CITY OF RIVERSIDE COUNCIL AGENDA RIVERSIDE CITY HALL COUNCIL CHAMBERS 60 N GREENE STREET

Friday, July 26, 2019 at 6:00 PM

Subject: RE: Highway 22 Riverside

Subject: New Sidewalk Slay

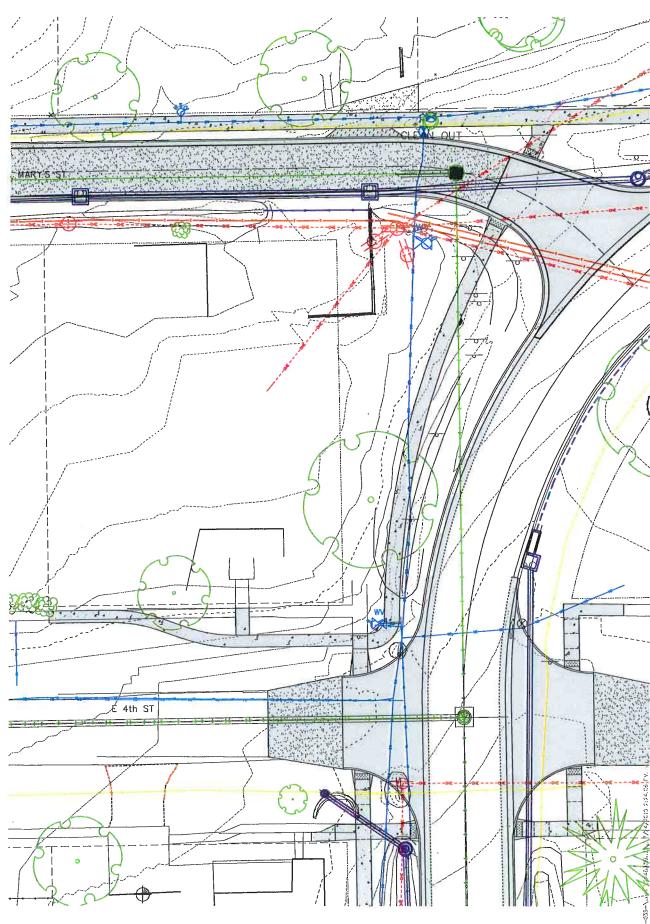
There is no justification related to safety or design criteria to support putting in a retaining wall. If this was necessary to meet ADA requirements or to address and protect the clearzone then it would warrant designing and constructing as a justified cost.

What happens on private property is beyond our jurisdiction unless it impedes highway sight distance from side roads. Please Verify that all of the wall is placed on private property.

What if the wall was constructed outside of the ROW here?

After discussion with Jim Armstrong, District Engineer, it has been decided that we do not support a retaining wall constructed in ROW for this area. This area does not warrant a retaining wall for the requested reason so let's not deviate from the current design.

The plans showed grading on to adjacent property in order to make the ADA sidewalks work at the NW corner of Highway 22 and 4th Street. In talking to the adjacent property owner he asked if the City could build a retaining wall instead. The reason is that he has had vehicles leave the roadway through the curve in the past and end up in his yard and home. He felt the slope up from the sidewalk almost was like a ramp if a vehicle did leave the roadway again and that a wall may help protect his home if that happened.

Attached is a preliminary design of a wall at this location. The City Council is OK with a wall at this location. I wanted to reach out to you to make sure the DOT was OK with a wall at this location. A portion of the wall would be within the ROW so I assume would require permission from the DOT.

Please review the attached and let me know if this would be OK. Let me know if you need additional information.

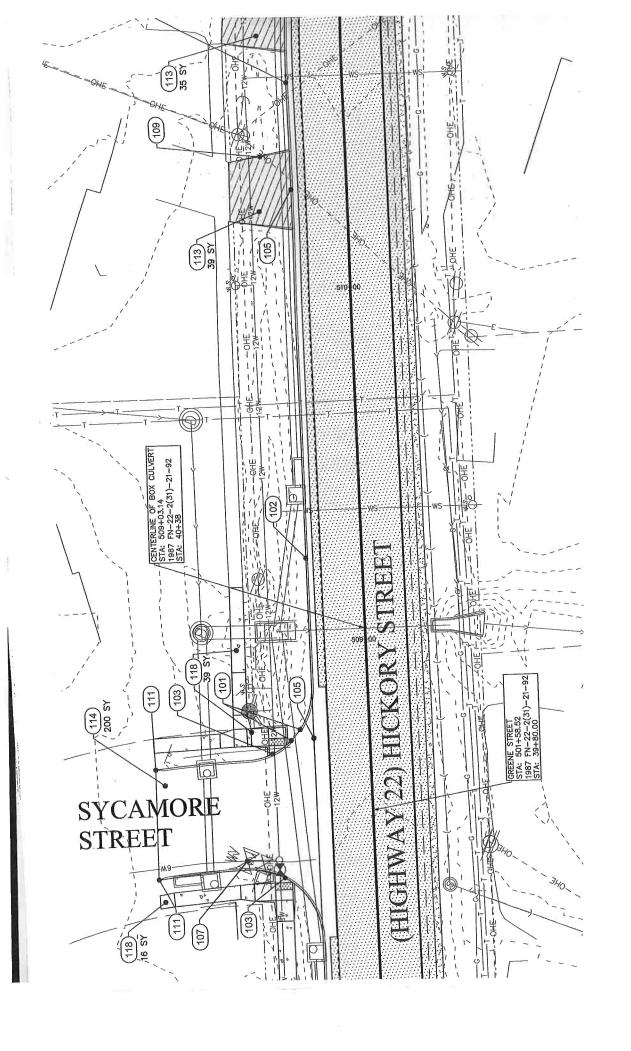
They did not want to go closer to the road by being on the other side of the hydrant. So if it could stay on the original alignment on Hwy 22 and then go farther down in the ROW on 4th they were good with that. You would just move the 4th Ave side down closer to the street as you were concerned about the steep slope from Hwy 22 going west correct? Otherwise it could just stay with the original alignment then there wouldn't be any additional cost. Are these changes being requested because a wall is not going to happen and the grading will be an issue? Is the grading possible without an alignment change?

I guess I am unclear as to which way they want to go. It looks like you say they want to keep the previous alignment along the highway but change along 4th?

The attachment shows what I was thinking would be built with this project in orange and with 4th Street project in pink.

Met with Edgar, Tom and Allen this afternoon and there are several questions on the proposed changes to the sidewalk:

- Everyone preferred the sidewalk to retain the original alignment on Hwy 22, but is ok with running it part way up 4th St. So make the change or leave the alignment along Highway 22 the same?

- Will all of the changes at the intersection meet ADA requirements? Any changes would have to comply with ADA
- What will be any additional cost and/or delay to the project? If we make the change to the new plan there will
 be a little extra cost for the sidewalk to Slay from the new alignment. I estimate about 10 SY additional sidewalk
 with the new plan. The only delay will be getting the grades worked out and getting it restaked.

- It appears that the original excavation for the project cut pretty deep into the hillside-could the tree possibly been saved if it hadn't been cut in so deep? The cut is required due to ADA requirements. The only way to have saved the tree is to move the sidewalk closer to the highway like we are now considering. Likely some roots would have still been damaged even at the new alignment but it would have been less damage.

Please distribute and let me know what everyone thinks. I think we connect at his steps for now so that would be a little more sidewalk but would be able to continue to the west with the 4th Street project.

I think the idea behind the changes was to try to come up with a plan which would not require a wall or grading outside of the ROW. If we stick with the original plan we would still need permission from Slay to grade on his property. That is where the whole wall idea came up when I started talking to him about getting permission to grade on his property.
